118 MERCER

SDCI #3036517-LU (3036455-EG)

DESIGN REVIEW BOARD RECOMMENDATIONS

08/04/21

EDG RESPONSES - 1E ART INTEGRATION

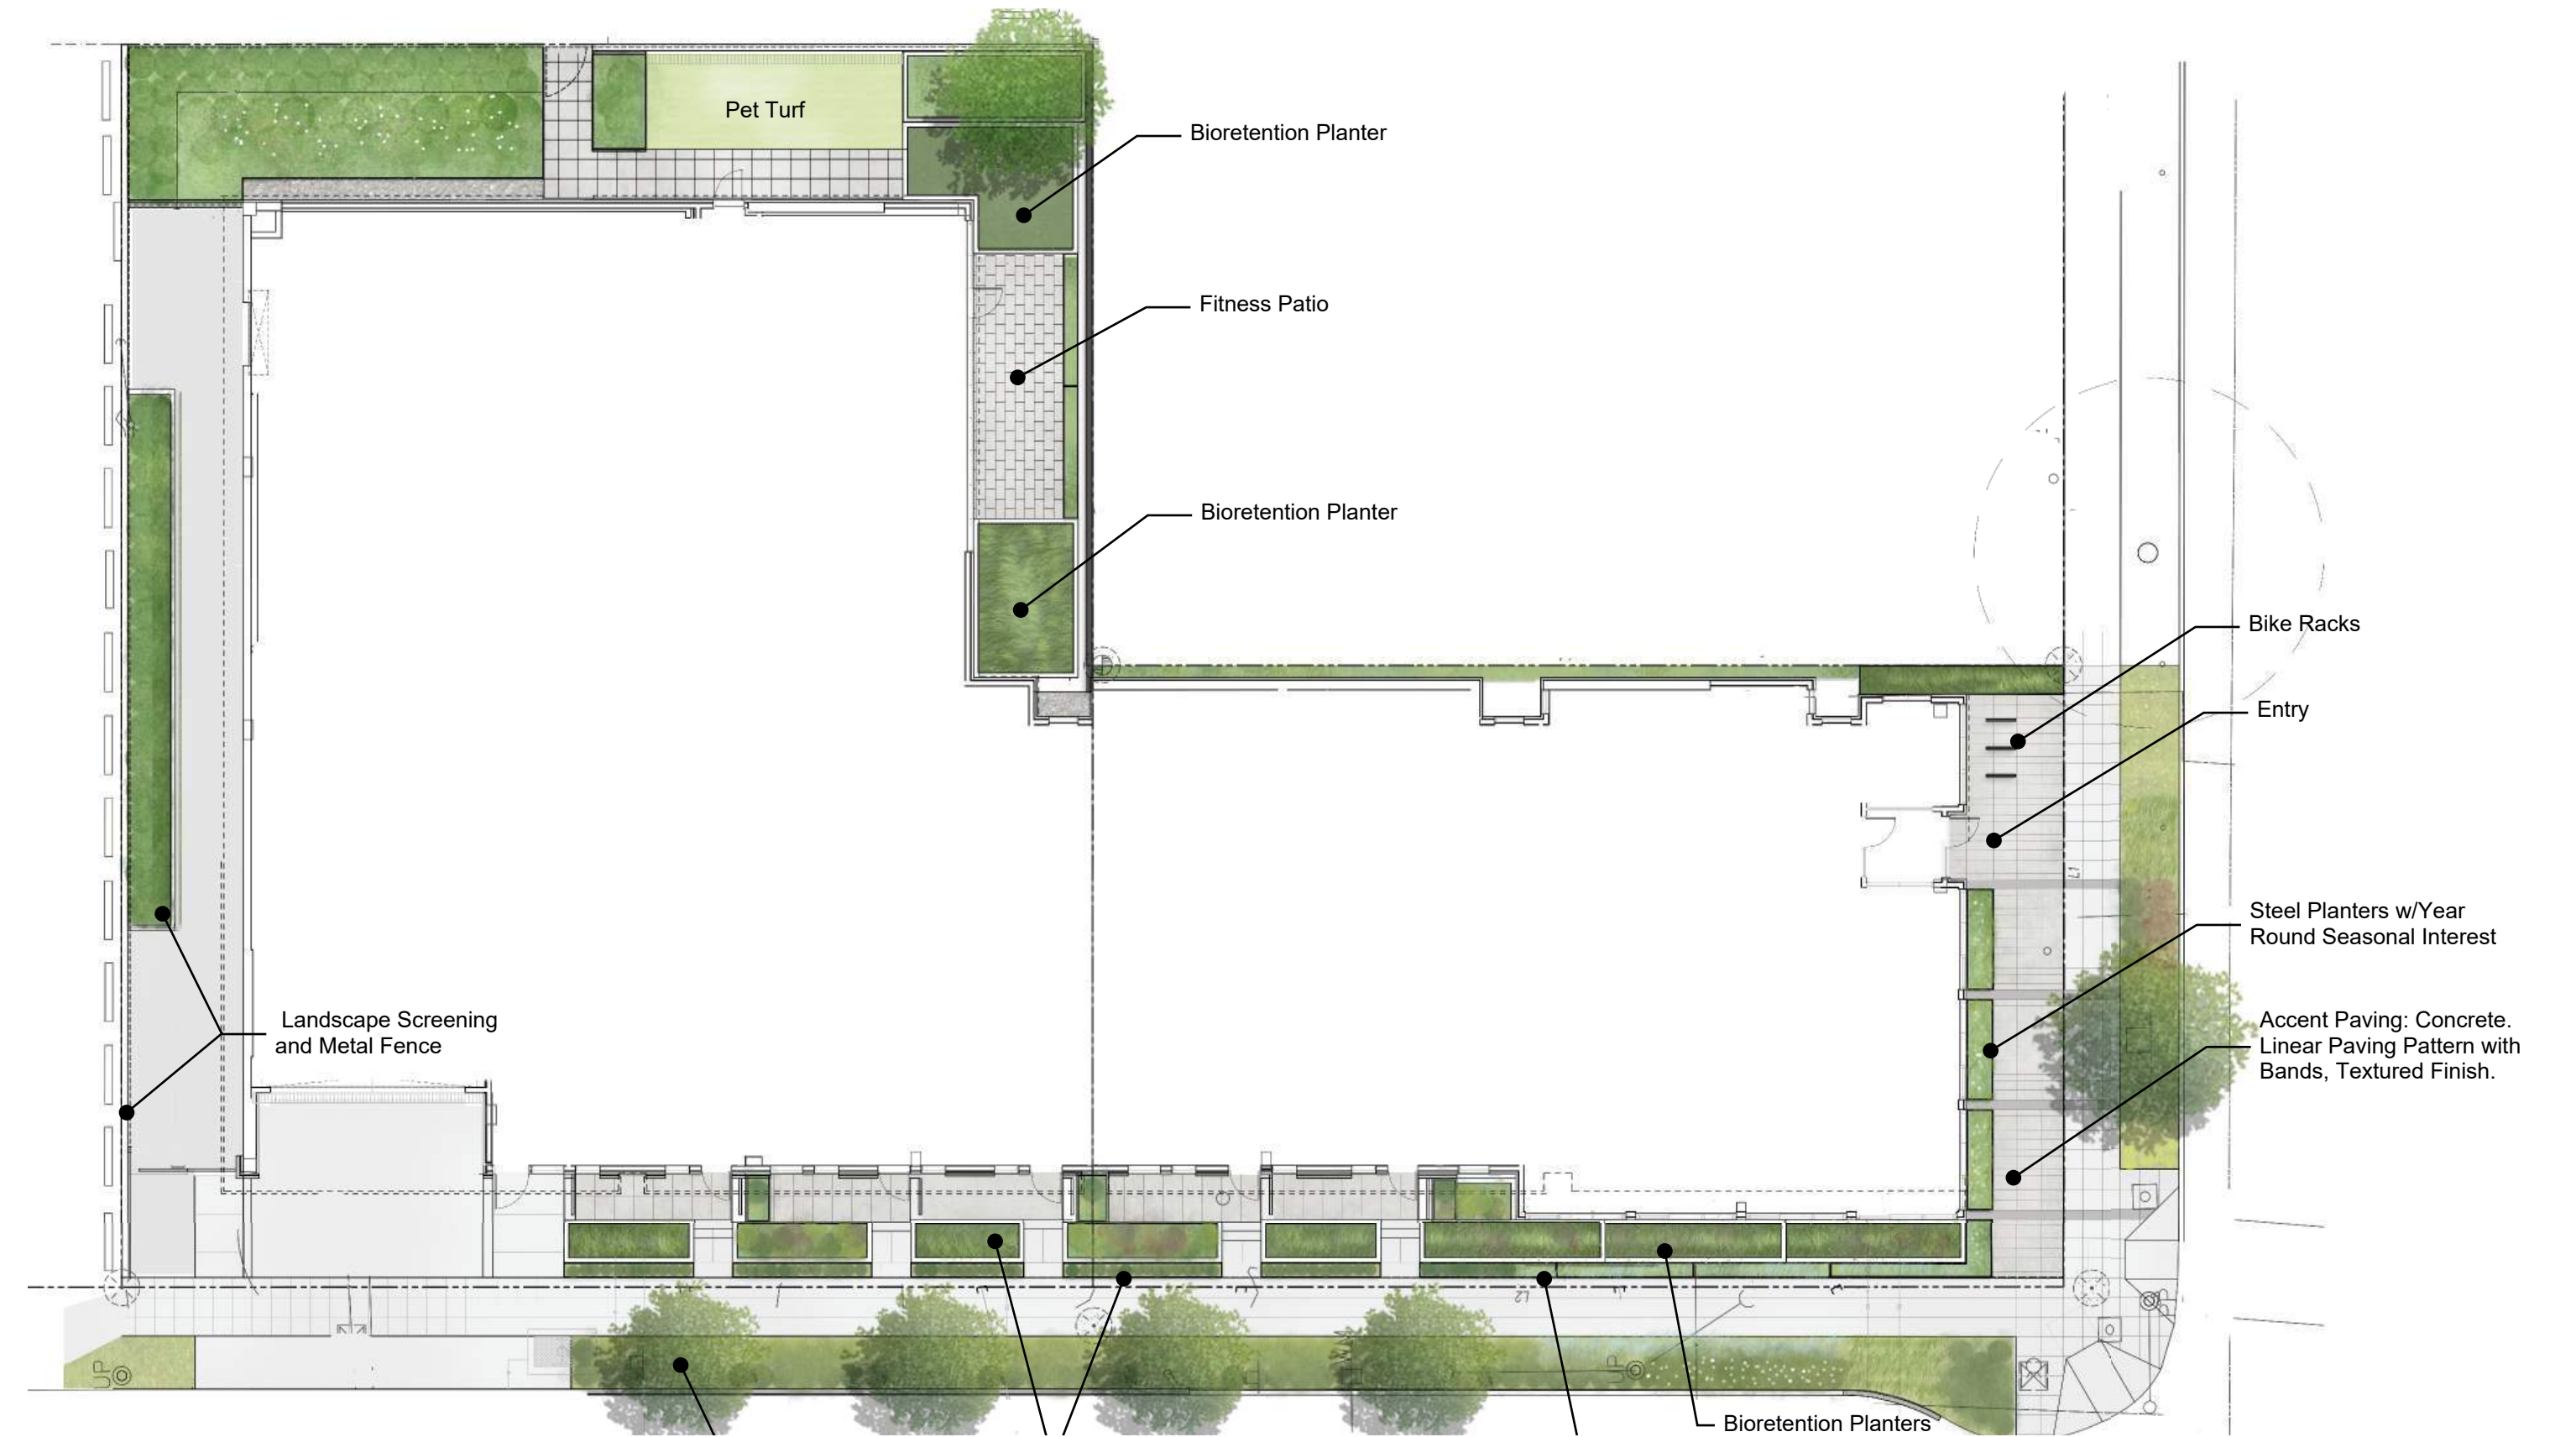
1e Expand on proposed artwork. "Elaborate on the intent & integration with the design."

The board identified (Artwork & Murals) as priorities, but didn't offer specific guidance related to these items. (CS3.1.b, DC2.2.a)

As noted in the previous EDG responses and throughout this DRB package, artwork remains an integral part of the design concept. Outreach to muralists and sculptors underway, with the goal of presenting final concepts to the Uptown Alliance for neighborhood approval in early summer. The design team does not intend to limit the artists' thematic approach, but has instead requested a holistic concept proposal that utilizes strong geometries that lends to pattern recognition between three dimensions (sculpture) and two dimensional (art panels/mural). Suggested inspirations include the greater Pacific Northwest, Uptown's history and the forms of the nearby Pacific Science Center.
